PG&E Letter DCL-12-016  
U.S. Nuclear Regulatory Commission

Response to NRC Request for Additional Information Regarding License  
Amendment Request 11-03, "Revision to Technical Specification 3.8.1, 'AC  
Sources - Operating' for Traveler TSTF-163, Revision 2, and Exception to  
Regulatory Guide 1.9, Revision 0"

**PG&E Response to NRC Request for Additional Information Regarding License Amendment Request 11-03, "Revision to Technical Specification 3.8.1, 'AC Sources - Operating' for Traveler TSTF-163, Revision 2, and Exception to Regulatory Guide 1.9, Revision 0."**

*TABLE 8.3-8 of the Diablo Canyon FSAR Update contains the following note:*

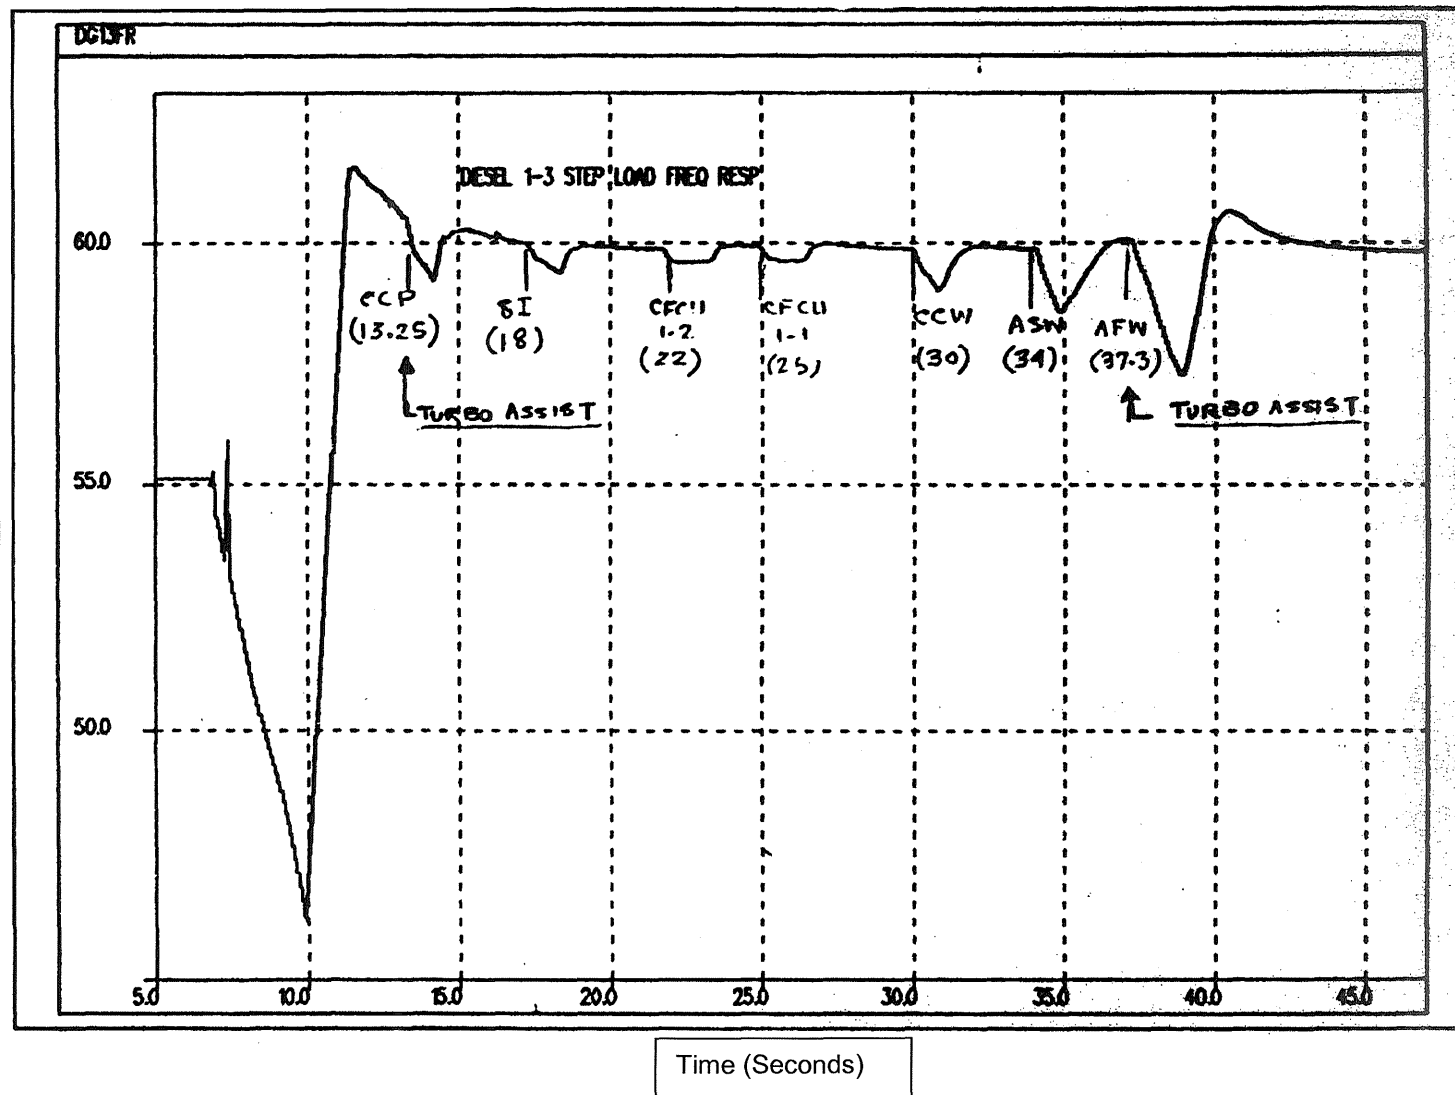
*Note 1: Original testing was done using a nominal 5-second load sequence time interval with the KWS relay installed. Since a nominal 4-second load sequence time interval is used in the design basis loading scenario and the EDG loading capability is demonstrated through computer simulation without KWS relays, the test results of Table 8.3-8 are of historical value.*

*Provide details on how the computer simulation results are validated with actual operation of large loads, specifically as related to voltage and frequency variations during sequencing.*

The Note 1 in Final Safety Analysis Report Update Table 8.3-8 refers to a one time computer simulation that was performed to support removal of the KWS relay. After removal of the KWS relay, DG loading surveillance testing was performed in the 1R7 and 2R7 outages with additional instrumentation to assess the actual DG voltage and frequency response to the RG 1.9 criteria. The computer simulation is no longer required or used to assess the DG voltage and frequency response. The reference to the computer simulation in FSAR Update Table 8.3-8 is historical information.

1R5 Diesel Generator 1-3

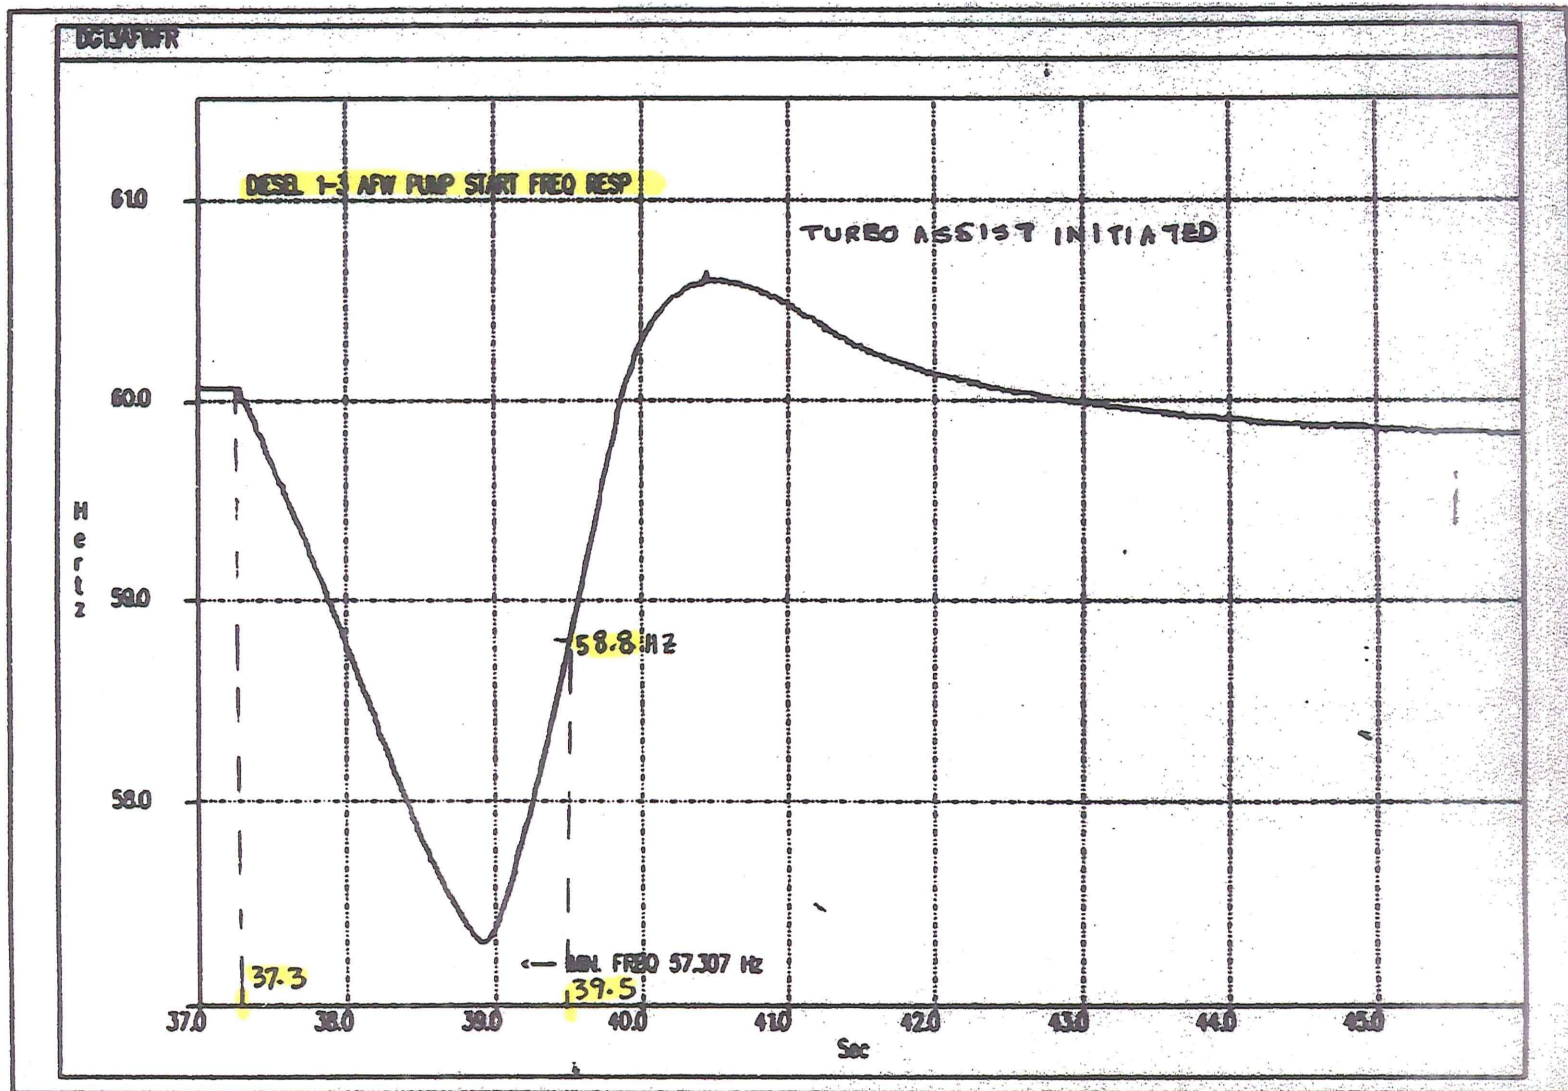
*Provide a summary of the test data from the 1R5, 2R5, 1R7, and 2R7 outages to demonstrate that there is adequate margin in the 4-second load timer interval to ensure that there is no overlapping of loads, that the DG frequency consistently stabilizes within a nominal 2.2 to 2.3 seconds, and that the DG is capable of starting and accelerating subsequent ESF loads.*

AFW pump 1-3 (DG 1-3) - frequency recovery time to within 2 percent of nominal was 2.2 seconds.
